Submittal #11 68 16-6.0 11 68 16 - Play Structures

Project: 190123 - Strawberry Park ES
39620 Amethyst Dr.
Steamboat Springs, Colorado 80487

Pre-K Shade Shelter Shop Drawings

COLUMN LAYOUT PLAN
SCALE: 3/8" = 1'-0"

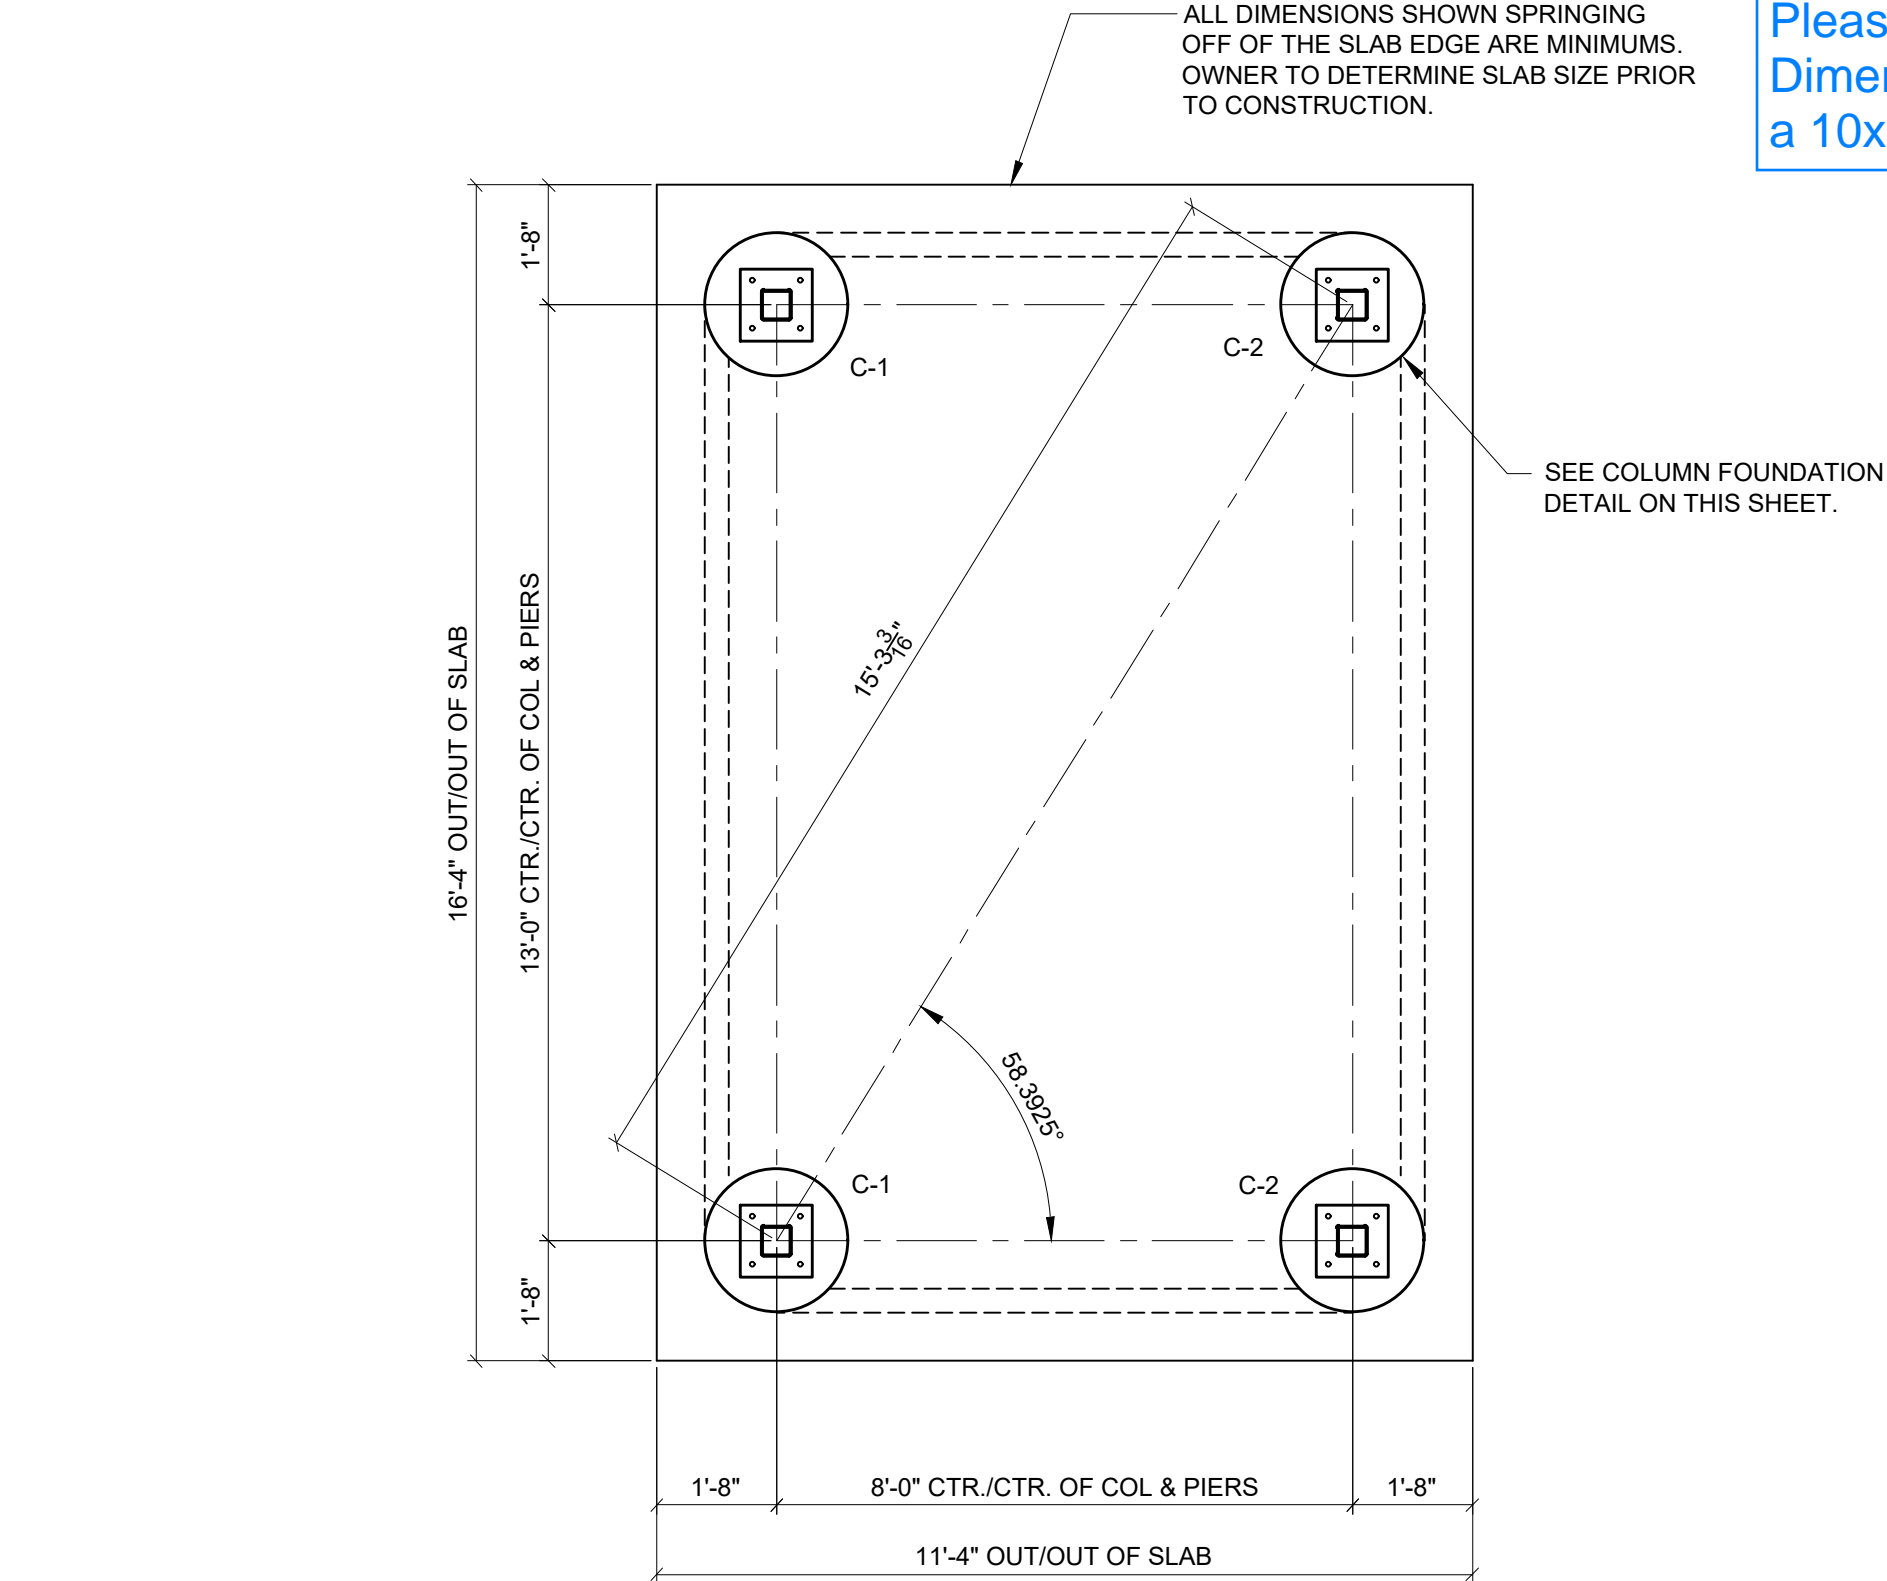
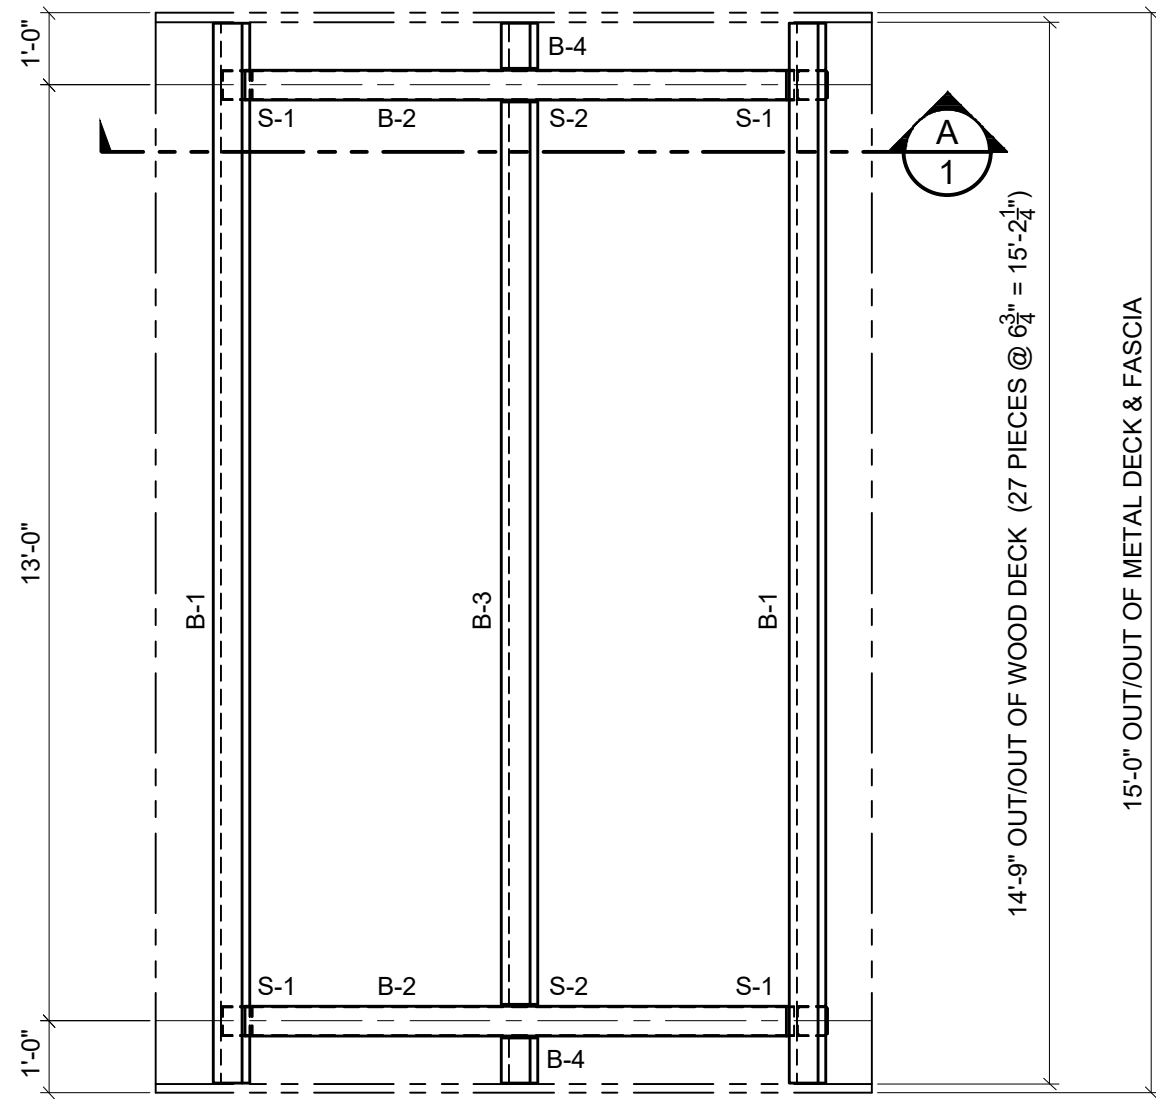
Shelter dimensions are approved at 10'x15'
